Determination Date: 5/20/20
Appeal Period End Date: 6/4/20

RE: Parcel Map No. AA-2019-4975-PMLA-SL
Related Case: None
Address: 5441-5443 ½ Blackwelder Street
Community Plan: West Adams – Baldwin Hills -
Leimert
Zone: RD1.5-1
District Map: 120B177
Council District: 10
CEQA No.: ENV-2019-4976-CE
Legal Description: 332, Block None, Tract Du Ray
Place

LOS ANGELES DEPT. OF CITY PLANNING
SUBMITTED FOR FILING
PARCEL MAP

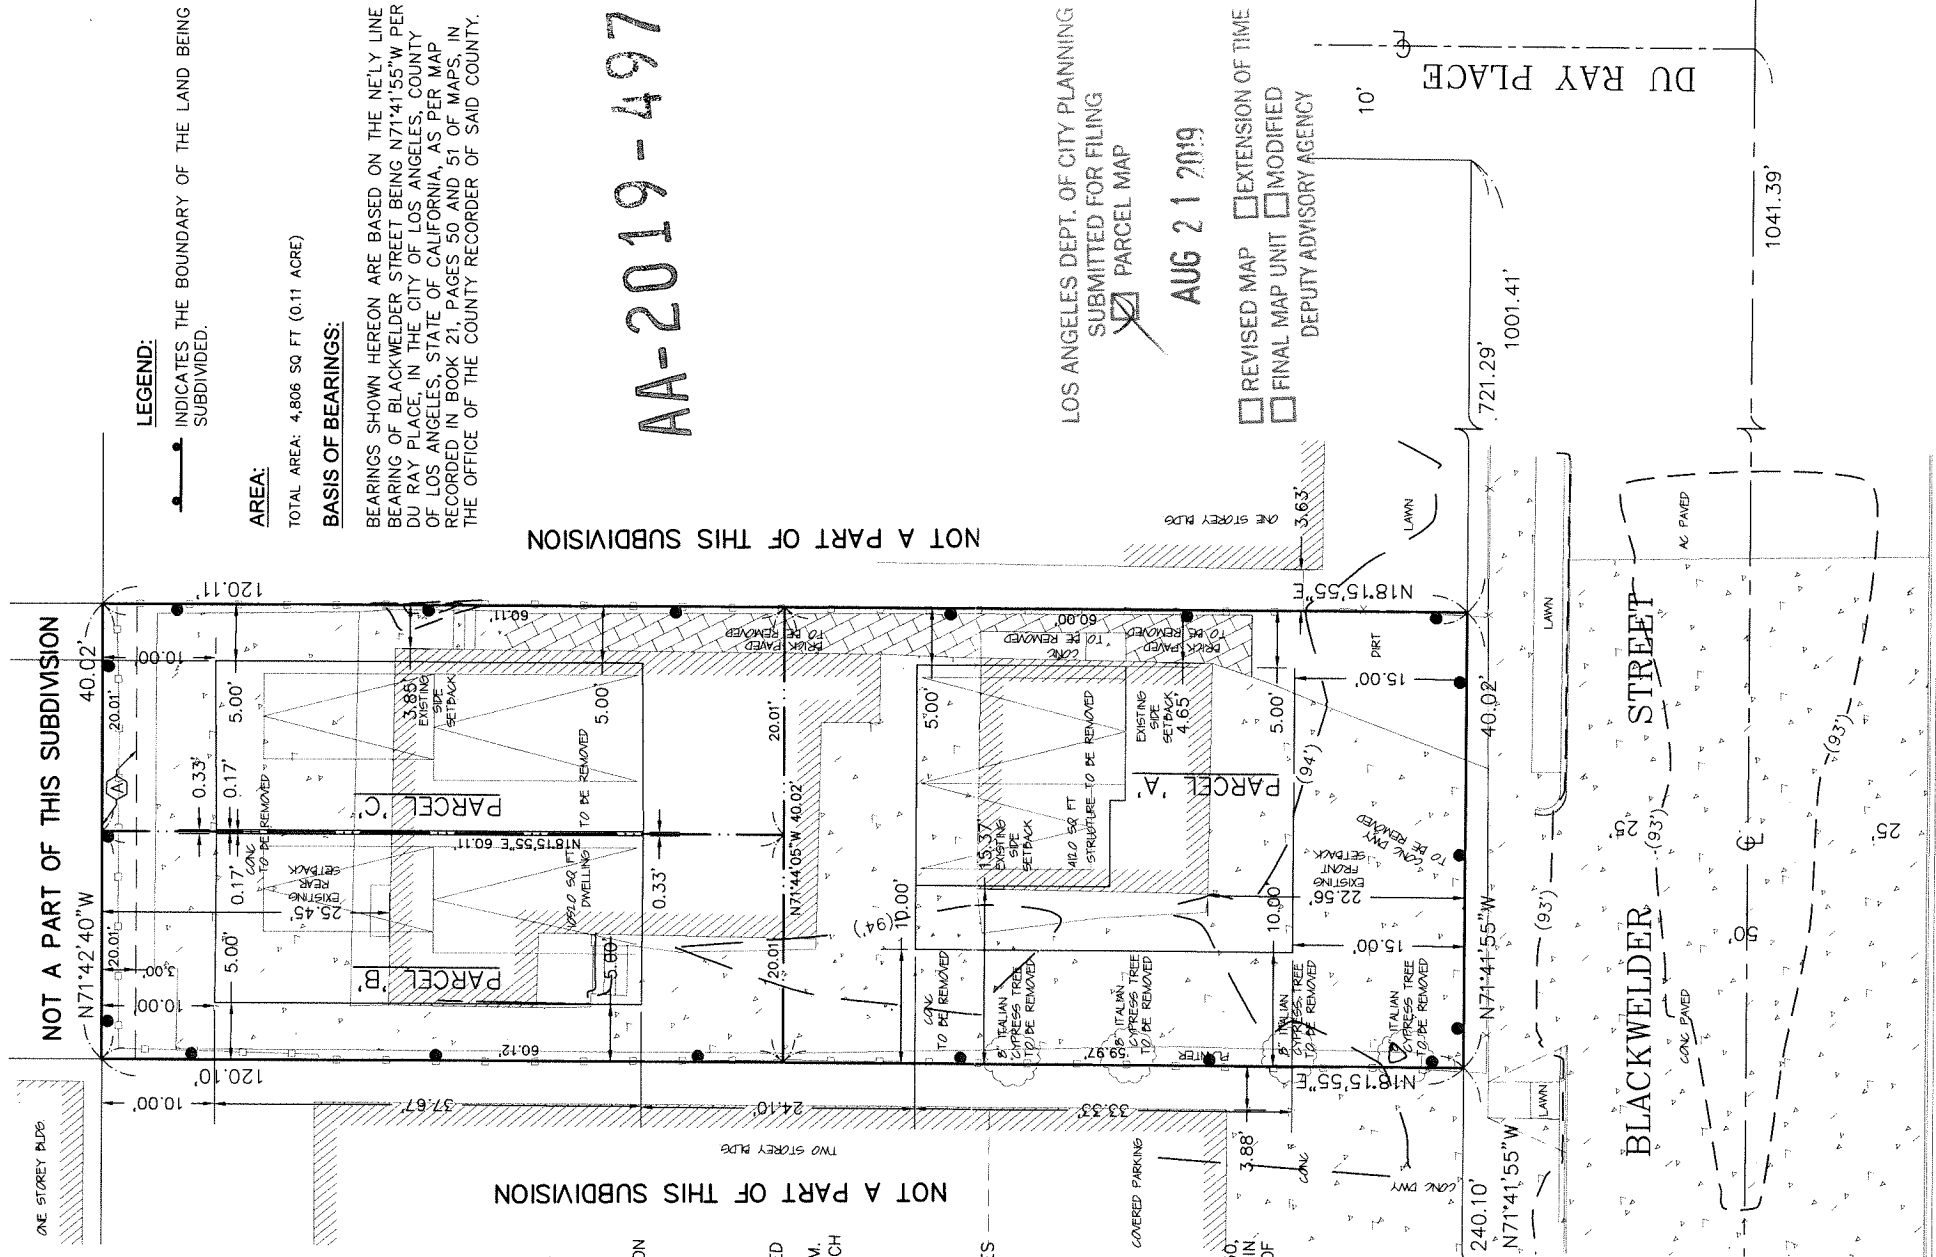
1. That a 5-foot wide strip of land be dedicated along Blackwelder Street adjoining the subdivision to complete a 30-foot wide half right-of-way in accordance with Local Street Standards of the LA Mobility Plan.

2. That a common access easements be clearly identified on the final map.
3. That if this parcel map is approved as "Small Lot Subdivision" then, if necessary for street address purposes, all the common access to this subdivision be named on the final map satisfactory to the City Engineer.

- b. Show all street dedication as required by Bureau of Engineering and provide net lot area after all dedication. "Area" requirement shall be re-checked as per net lot area after street dedications. Front yard requirement shall be required to comply with current code as measured from new property lines after all dedications.

- c. Provide and dimension the reciprocal private easement for pedestrian and driveway egress and ingress in the final map.

Setbacks				
Parcel	North	South	West	East
A	12' (RY)	15' (FY)	5' (SY)	5' (SY)
B	10' (FY)	12' (RY)	5' (SY)	0'-4" (SY)
C	10' (FY)	12' (RY)	0'-4" (SY)	5' (SY)
